Falcon Highlands

Final Drainage Report

Provide PCD file No.
SF2418

June 10, 2024

COUNTY FILE NO.:
 DR. TN CH. KB
 P.M. DM
 JOB 24004308
 SHEET NO. 2

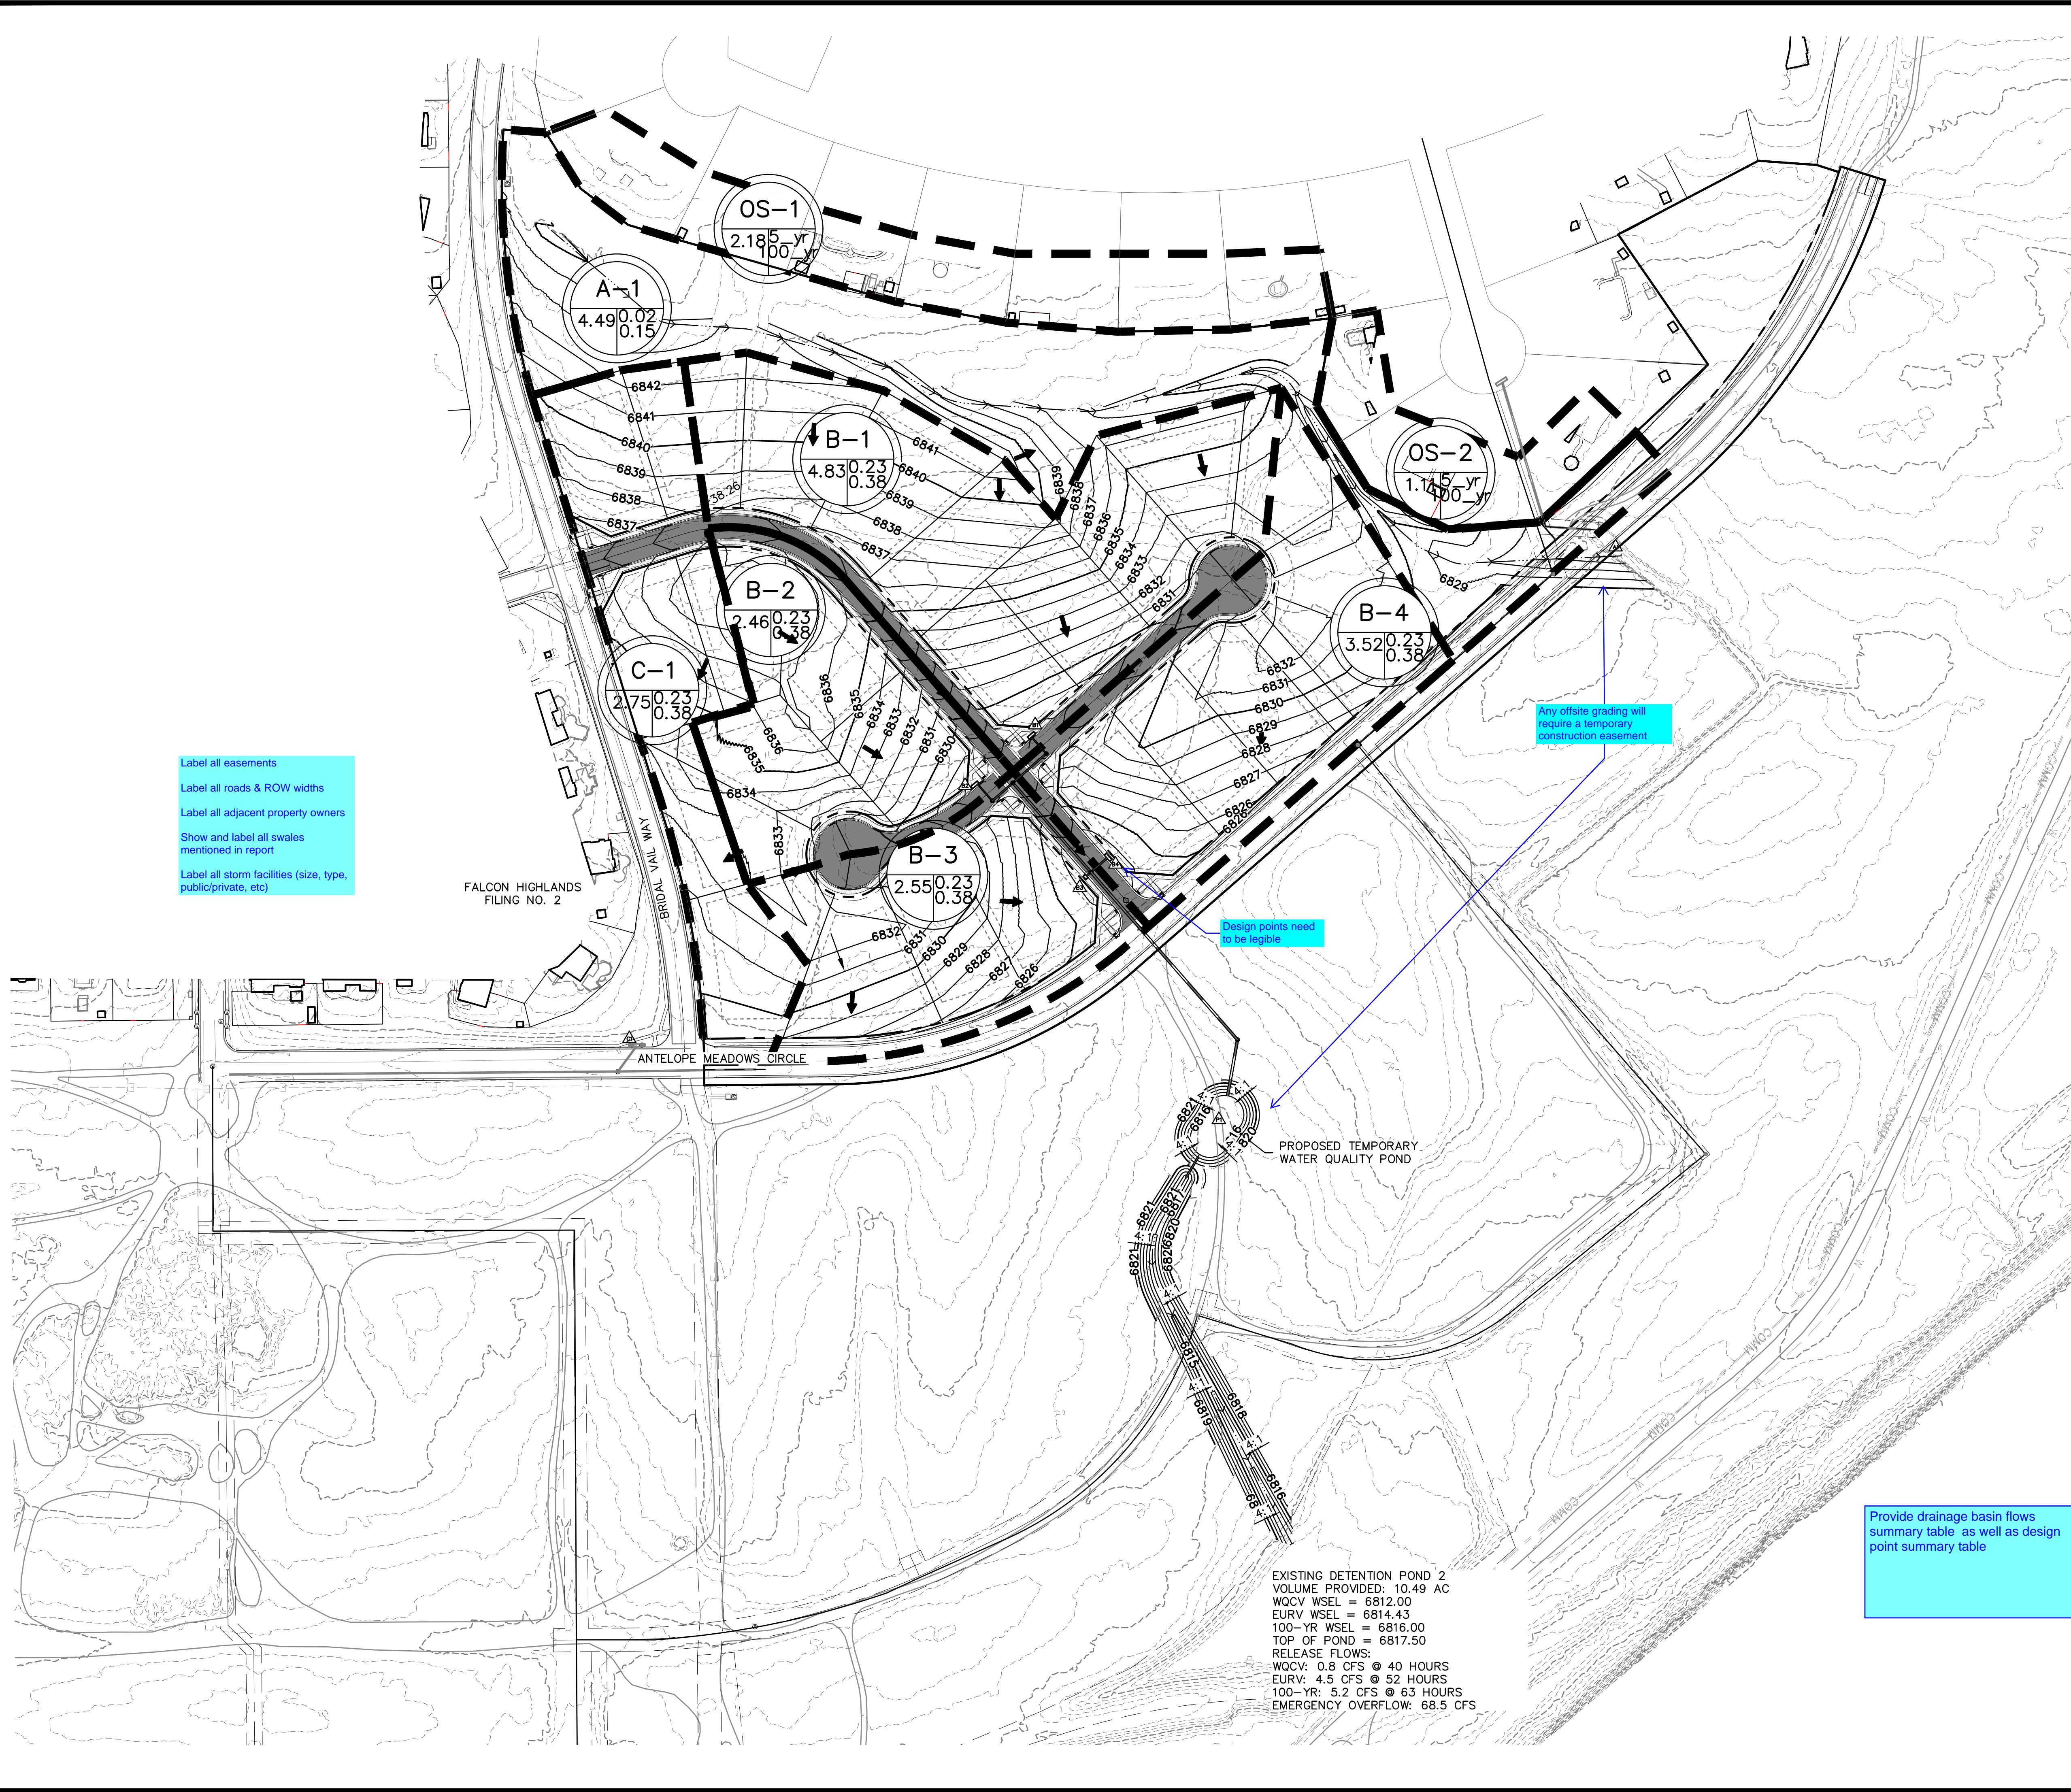
Label all easements
 Label all roads & ROW widths
 Label all adjacent property owners
 Show and label all swales mentioned in report
 Label all storm facilities (size, type, public/private, etc)

Any offsite grading will require a temporary construction easement

Design points need to be legible

Provide drainage basin flows summary table as well as design point summary table
